Final Plat - Fifth Addition to Merri-Hill Addition Village of Oregon

Plat consists of 12 lots, 2 Outlots, 9.84 acres.

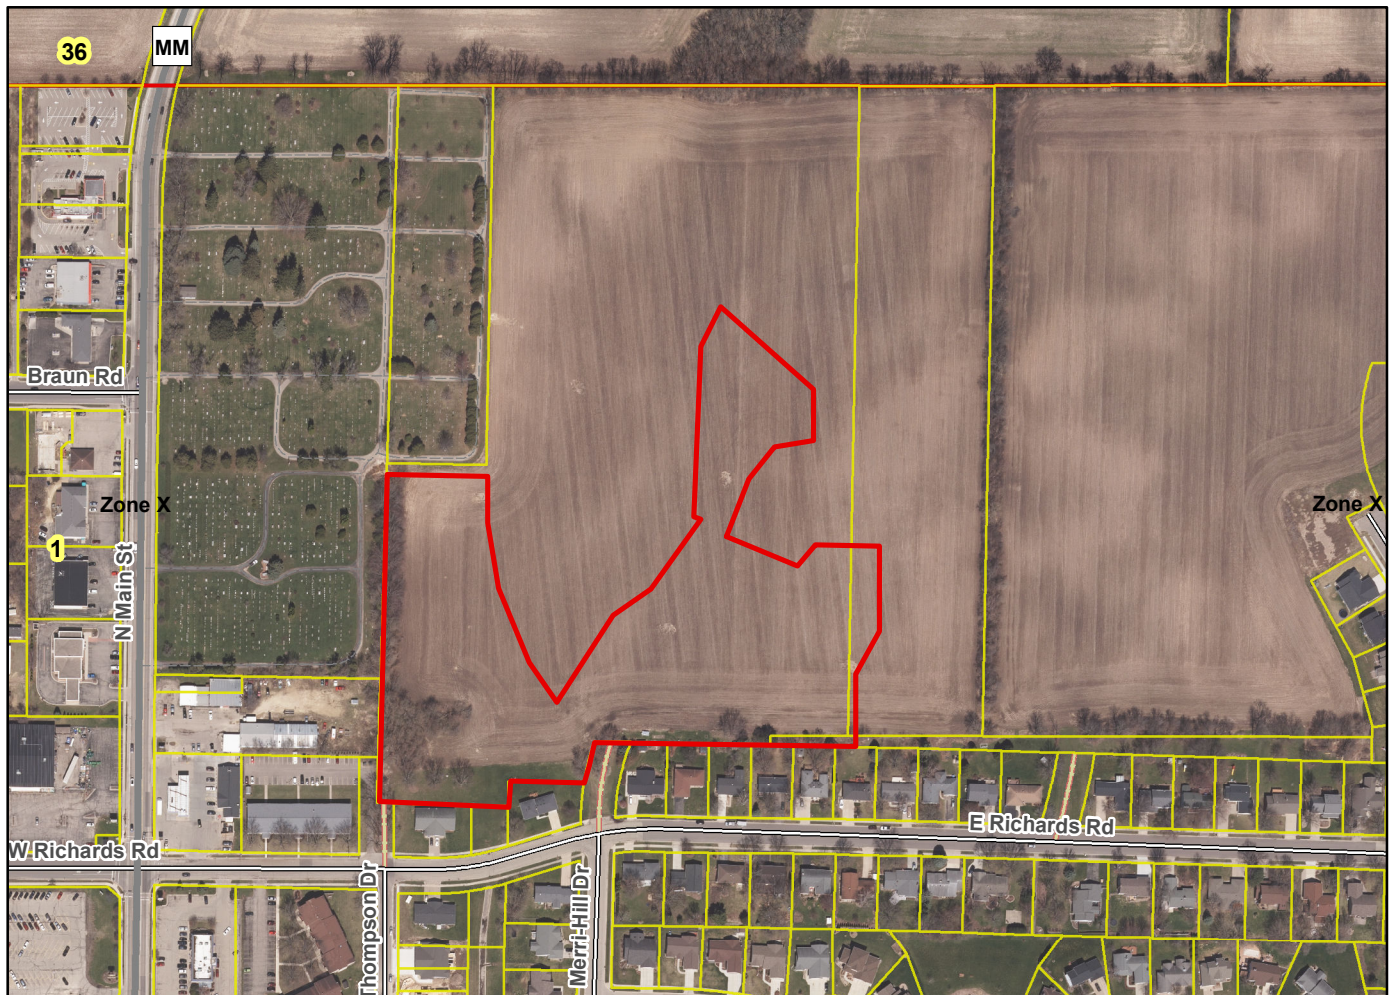
Parks - OL 4 dedicated to the public for park purposes.

Parkways - none

Expressways - N/A

Major Highways - CTH MM (Main St.) to the west.

Airports - Dane County Regional

Drainage Channels - Drainage arrows shown indicate the direction of surface drainage swale at individual property lines.

Schools - established
